INTRODUCTION THM 4T65-E UPDATE HANDBOOK

THM 4T65-E UPDATE HANDBOOK

Figure 21

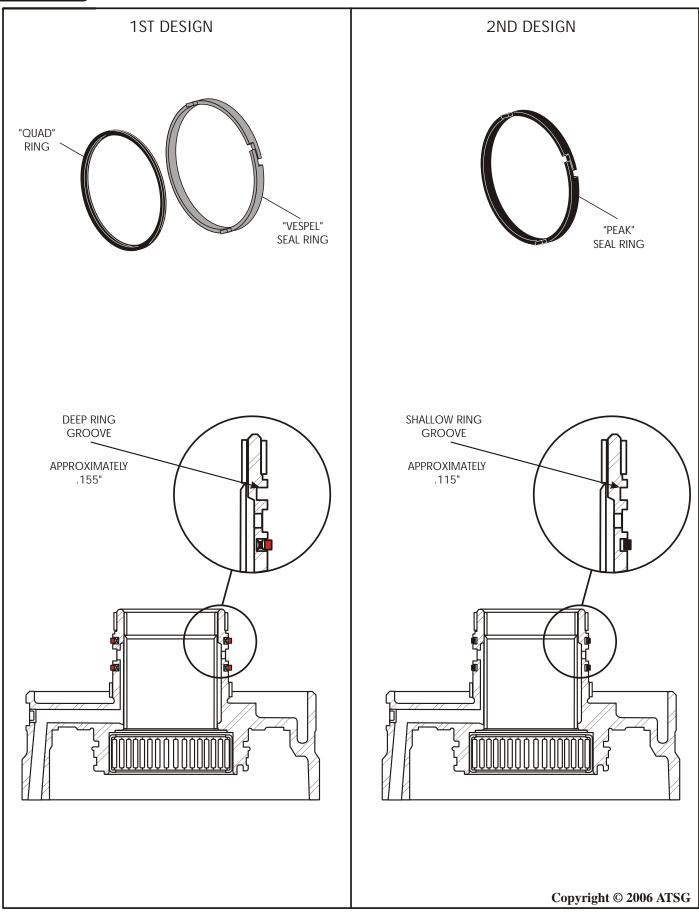
- (1) RUBBER QUAD-RING The rubber quad-ring, that was used in the seal groove under the "Vespel" seal ring as an expander, was eliminated (See Figure 21).
- (2) VESPEL SEALING RINGS The Vespel material sealing rings were replaced with a "Peak" material at the same time (See Figure 21). The "Vespel" seal rings are Brown in color, and the "Peak" seal rings are Black in color.
- (3) DRIVEN SPROCKET SUPPORT The seal ring grooves were not machined as deep on the second design sprocket support, to accommodate the new design seal rings without the rubber quad rings. The groove depth on 1st design is approximately .155", and groove depth on the 2nd design is approximately .115". Refer to Figure 21.

The second design driven sprocket support and the "Peak" 2nd clutch sealing rings will back service *all* previous models of the 4T65-E.

The first design driven sprocket support *must* be used with the rubber quad-rings.

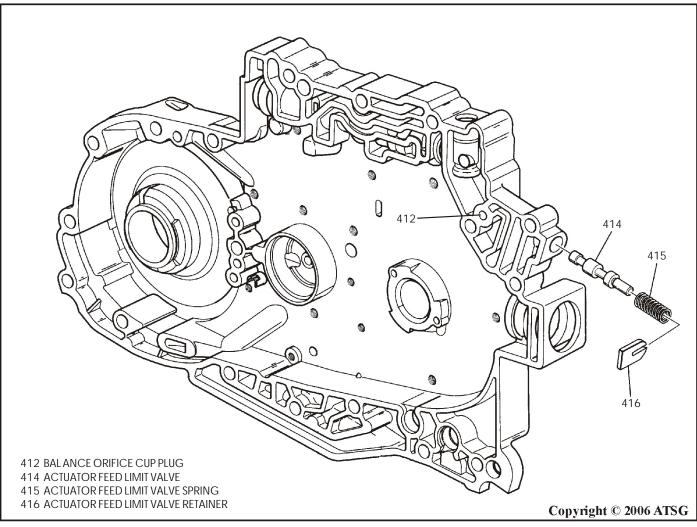
- CAUSE: One cause may be a stuck Actuator Feed Limit Valve, located in the channel plate, as seen in Figure 26. With this valve stuck, solenoid feed oil to shift solenoid 1-2/3-4 is either blocked or has insufficient flow rendering the solenoid inoperable as if the solenoid failed in the stuck off position mechanically. Shift solenoid 2-3 is not fed with Actuator Feed oil allowing it to continue to function as designed and thereby causing only second and third gears to be available, irregardless of the proper shift commands being provided by the computer. Also, inspect the orifice cup plug (412), as shown in Figure 26, for any debris that may be clogging the orifice.

CORRECTION: Free the Actuator Feed Limit valve.

Figure 30

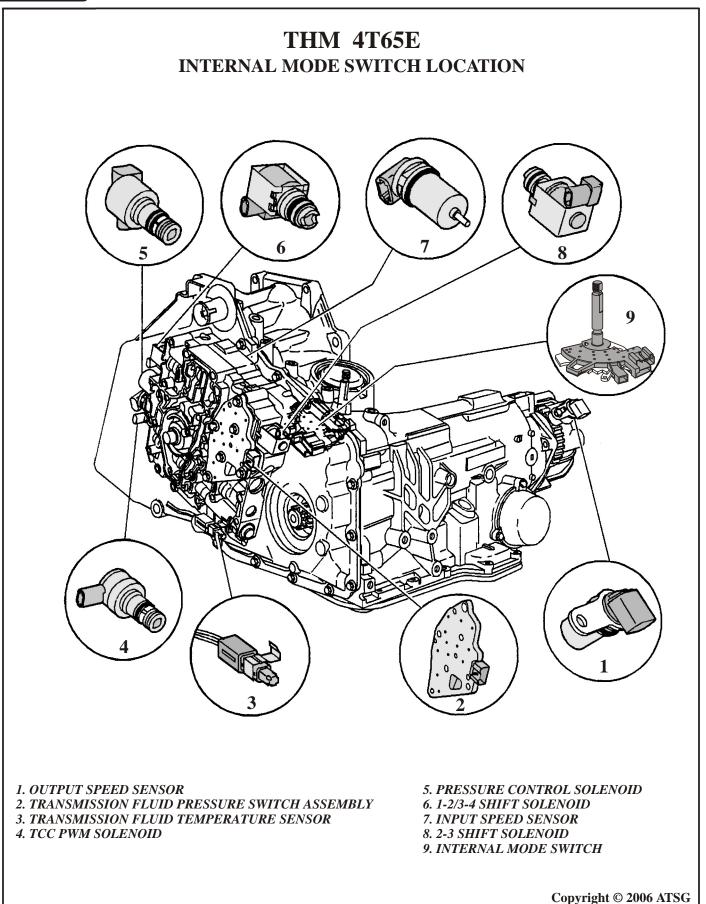
- (1) MODE SWITCH Now mounted internally instead of externally on the transaxle case, and applies to only *some* models (See Figure 30).
- (2) INTERNAL WIRE HARNESS Five wires added to the internal harness to accommodate the new mode switch that now run through the transaxle case connector (See Figure 31).
- (3) MANUAL VALVE LINK Was made shorter to accommodate the added internal mode switch, as shown in Figure 31. We have also included other model manual valve links for comparison.
- (4) MANUAL VALVE Was made longer to accommodate the added internal mode switch, as shown in Figure 31.

Figure 38

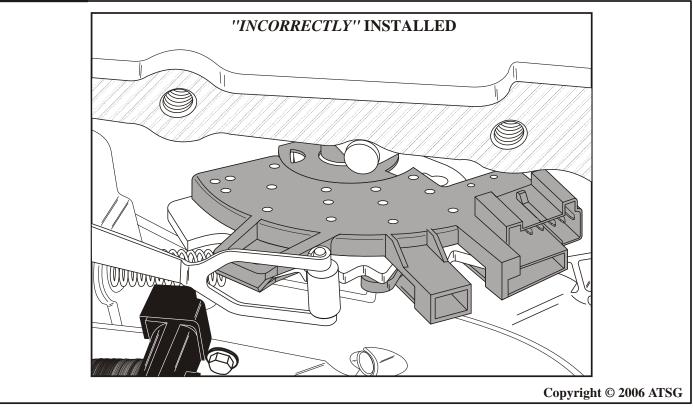
- CAUSE: When the detent spring was installed during the overhaul, it *was not* indexed in its proper location at the IMS which can be seen in Figure 38. When this is done the IMS can move across the detent lever ¹/₄" in either direction. Therefore movement of the shift lever is not synchronized with the IMS causing the above complaints.
- **CORRECTION:** Install the detent spring at the IMS as shown in Figure 39. *It is the detent spring roller that properly indexes the IMS.* When the IMS and detent spring are indexed correctly, there will be no movement of the IMS across the detent lever.

Figure 39

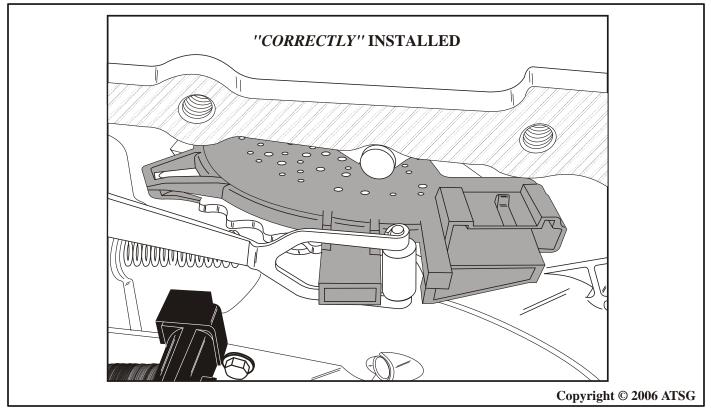
The new Internal Mode Switch also allows you to make an assembly error on the installation. Refer to Figure 38 for the most common "Incorrect" assembly, and refer to Figure 39 for the "Correct" assembly of the Internal Mode Switch. Refer to the description of the complaint below, when and if, you do install it wrong.

Figure 43

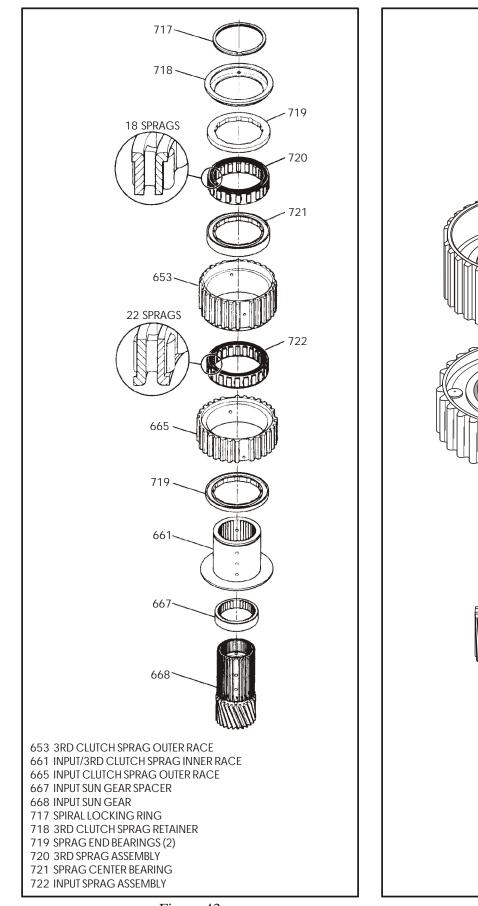
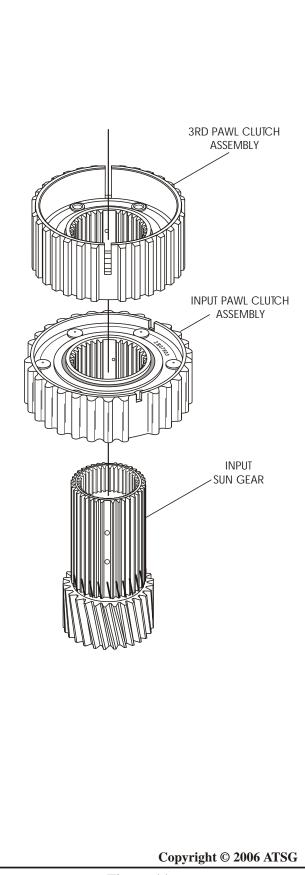
- **CHANGE:** Some 2003 model THM 4T65-E transaxles will come equipped with a newly designed Input and Third "Pawl" Clutch Assembly instead of the previous design Input and Third Sprag Clutch, as shown in Figures 43 and 44. This was implemented at start of production for the 2003 model year.
- **REASON:** Ease of assembly and cost savings.

- (1) INPUT "PAWL" CLUTCH The new design outer race has 30 splines instead of the previous 32 on the Input Sprag and cannot be disassembled like the previous design Sprag Clutch, which obviously makes the assembly process easier. Refer to Figures 43 and 44 for illustrations of both designs.
- (2) INPUT CLUTCH FIBER PLATE The new design fiber plate has 30 teeth instead of the previous design 32 teeth, to accommodate the new design "Pawl" Clutch Assembly. Refer to Figure 45 for illustrations of both designs.
- (3) THIRD "PAWL" CLUTCH The new design cannot be disassembled, like the previous design Sprag Clutch, which obviously makes the assembly process easier. Refer to Figures 43 and 44 for illustrations of both designs. The third clutch fiber plates remain the same as previous models.

Figure 52

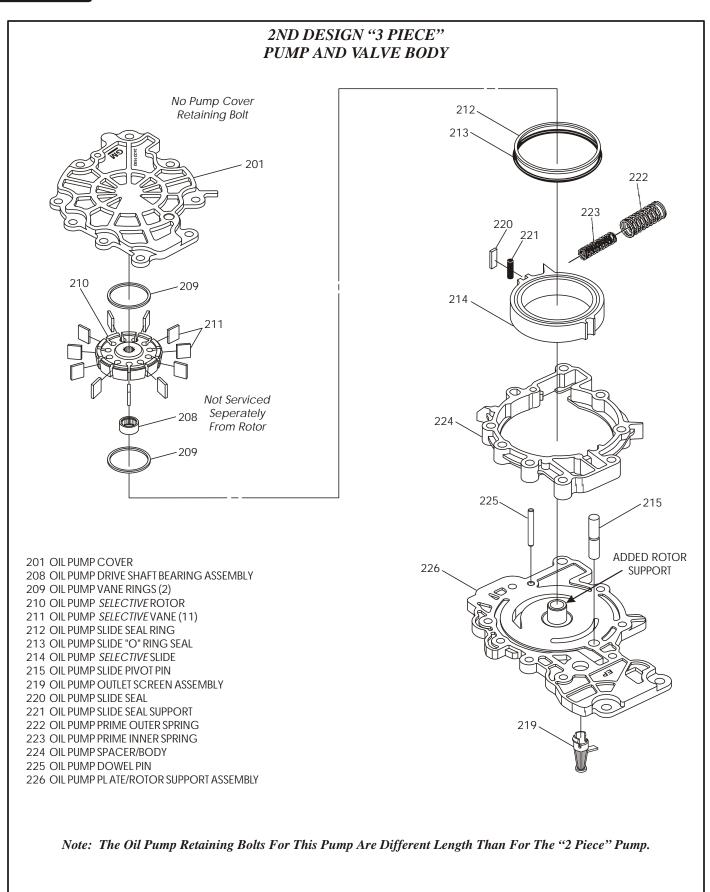
- (1) OIL PUMPASSEMBLY Changed to a "3 Piece" design, as shown in Figure 52. The "3 Piece" design now incorporates the rotor support sleeve in the pump instead of the valve body. The previous design "2 Piece design level pump is illustrated in Figure 51.

Figure 53

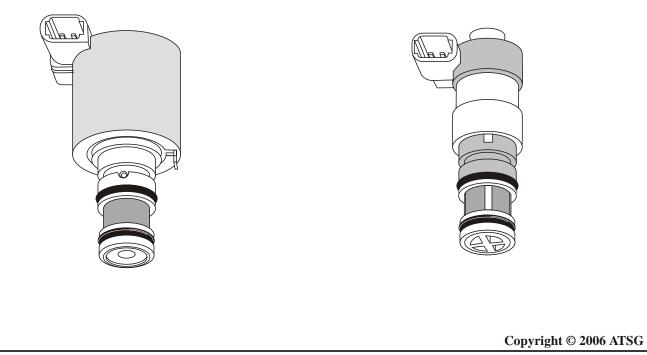
- (4) PRESSURE SWITCH ASSEMBLY Changed to a much smaller Pressure Switch Assembly with the elimination of all switches except the TCC switch, as shown in Figure 53.

- (5) INTERNAL WIRE HARNESS ASSEMBLY Changed to accommodate the 2nd design (Smaller) Pressure Switch Assembly.
- (6) PRESSURE CONTROL SOLENOID Solenoid that is much smaller than the previous design, as shown in Figure 53, for improved line pressure control.

Figure 56

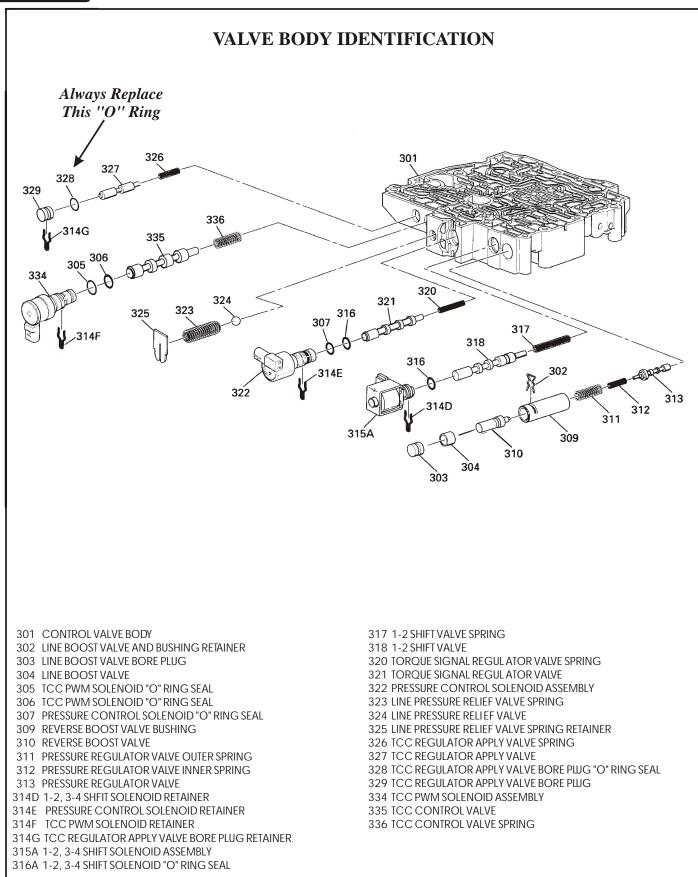
- **CAUSE:** The cause may be, a leaking bore plug "O" ring on the Torque Converter Regulator Valve train. Refer to Figure 54 to see a partial hydraulic circuit of the Torque Converter Regulator valve when the TCC is released. Refer to Figure 55 to see a partial hydraulic circuit of the Torque Converter Regulator valve when the TCC is applied. Notice, when there is a leak in the TCC Signal Circuit, the torque converter regulator valve may move to the left causing insufficient converter apply pressure, allowing the Torque Converter Clutch to slip, causing a surging sensation or the P0741 code.

- **CORRECTION:** Refer to Figure 56 and 57 for the valve locations in the valve body and replace the "O"ring on the Torque Converter Regulator Valve bore plug, item number 328, as shown in Figure 56.

Figure 68

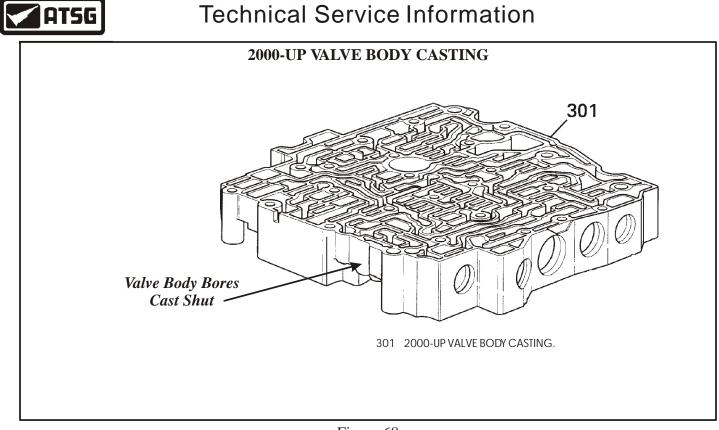
- (1) SERVO BOOSTVALVES Complete valve trains eliminated, as shown in Figure 68.
- (2) VALVE BODY CASTING Servo boost valve bores are now cast shut, as shown in Figure 68.

Figure 72

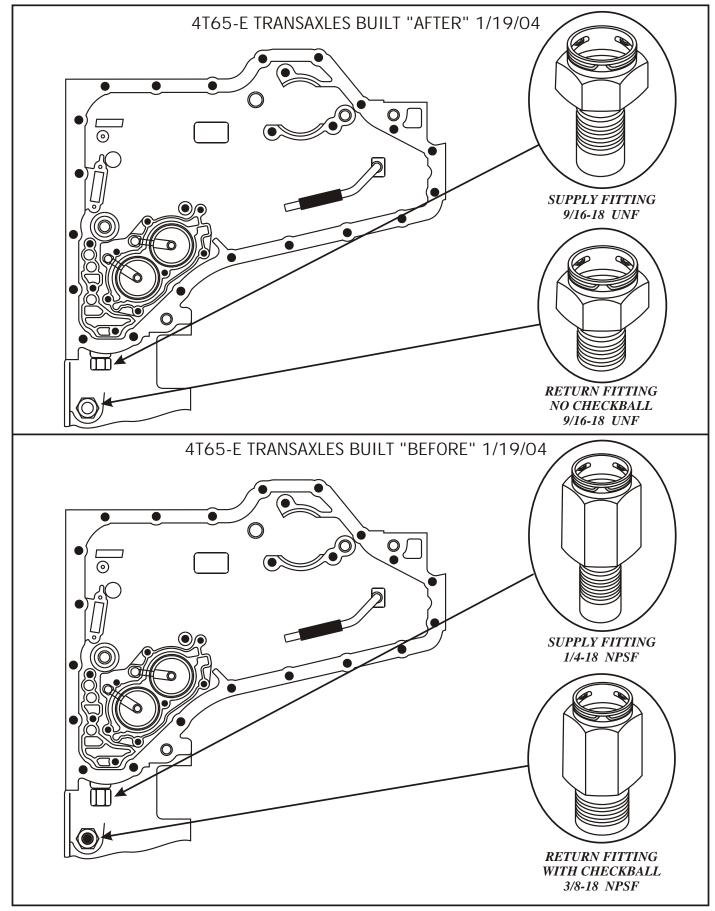
- (1) CHANNEL PLATE Drainback ball, spring, and retainer added to the channel plate next to the torque converter blow-off ball and spring. Channel Plates built "Before" January 19, 2004 are shown in Figure 70, and the Channel Plates built "After" January 19, 2004 are shown in Figure 71.
- (2) RETURN COOLER FITTING The January 19, 2004 and later cooler line case fittings both have the same threads, which is 9/16-18 UNF, and the return line cooler case fitting does not contain a ball and spring. Refer to Figure 72. The prior to January 19, 2004 cooler line case fittings have different threads. The supply cooler line case fitting has a 1/4-18 NPSF thread. The return line cooler case fitting has a 3/8-18 NPSF thread, and contains the drainback ball and spring. Refer to Figure 72.

When Channel Plate replacement is required, make certain that the 'Drainback/Cooler Blow-Off ball and spring is present, and in the proper location for the model year transaxle you are rebuilding.
